OCP NIC 3.0 Design Specification

Version [0.840-83](#)

Author: OCP Server Workgroup, OCP NIC subgroup

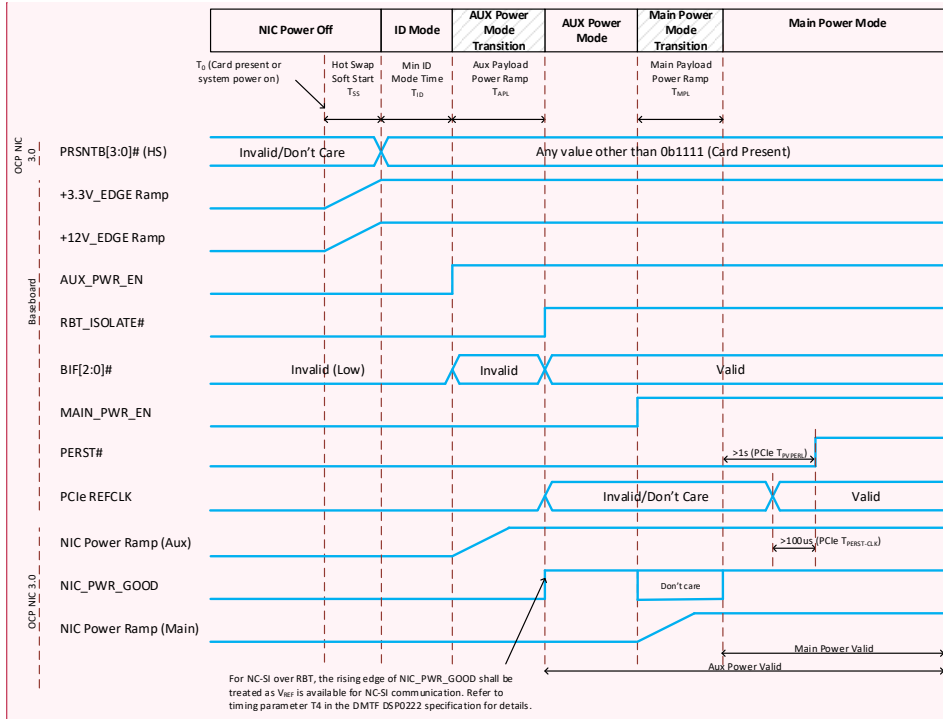
2) BIF[0:2]# pins valid at AUX_PWR_EN assertion is problematic for dynamic bifurcation.. Possibly move BIF[0:2]# valid to prior NIC_PWR_GOOD but the timing need to be specified to prevent concerns w/ system driving unpowered (or ramping) I/O pins.

3) Propose to add NC-SI start-up timing from DMTF DSP0222 spec of "T4 – Network Controller Power up ready interval – 2s max" from NIC_PWR_GOOD to RBT ready to power-up sequence in Fig 94. RBT can also be shown to be isolated prior to this timing.

Figure 995: Power-Down Sequencing

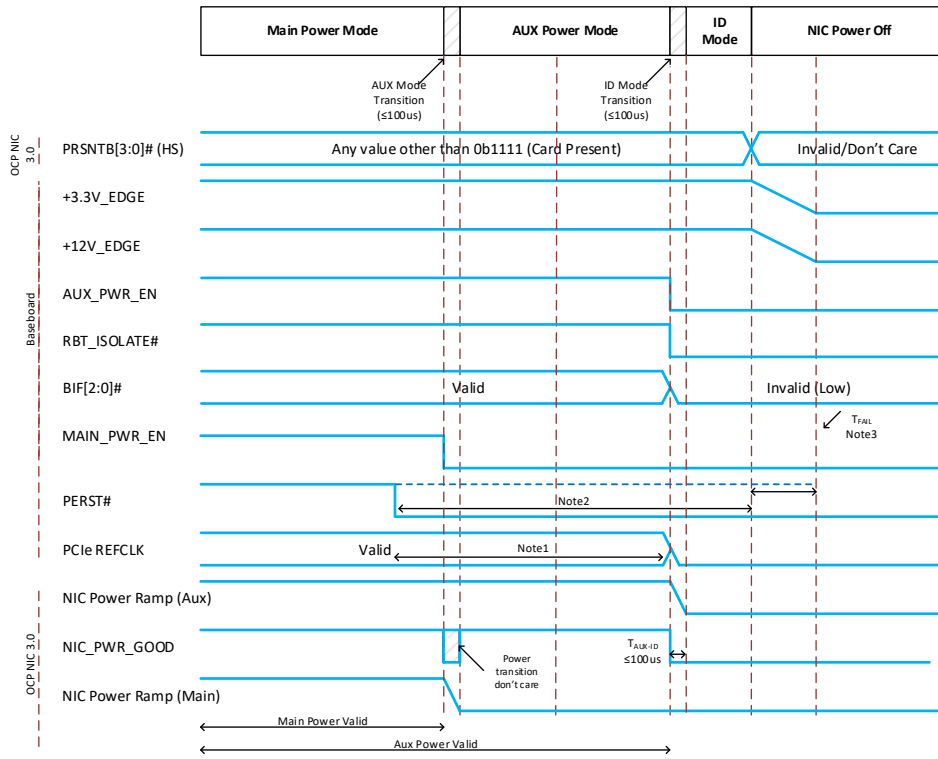
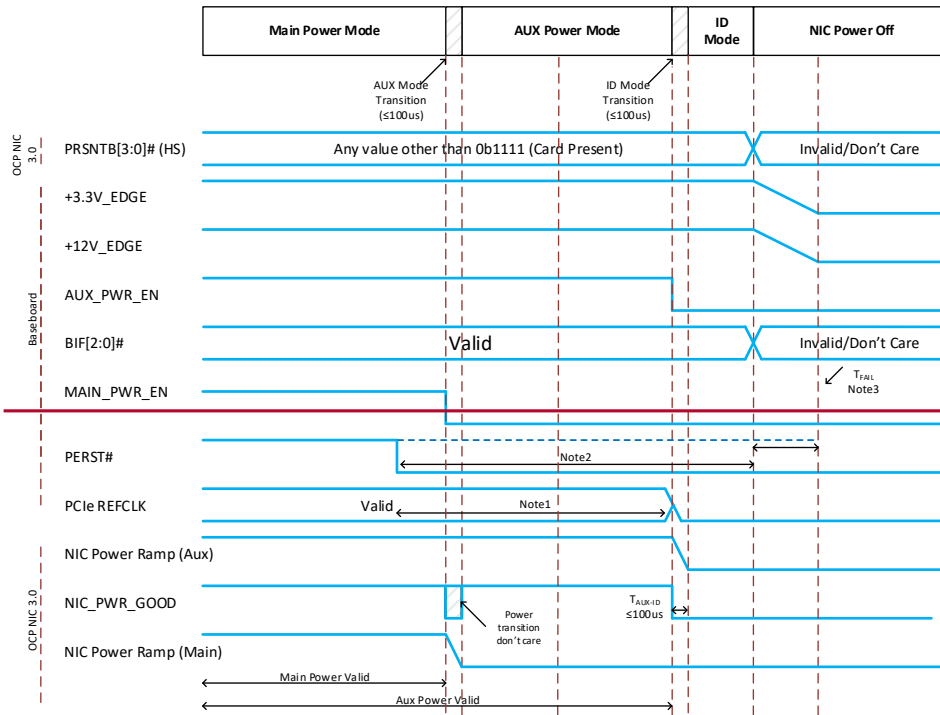
1)For dynamic bifurcation use case where 3_3V_EDGE/12V_EDGE are still up, need minimum time duration for AUX_PWR_EN and MAIN_PWR_EN to stay down for NIC cards to completely discharge downstream VRs to prevent unintended side effect if the system come back up too fast.

2)Taux-ID <=100uS in diagram. Table 37 shows Taux-ID = 10ms?
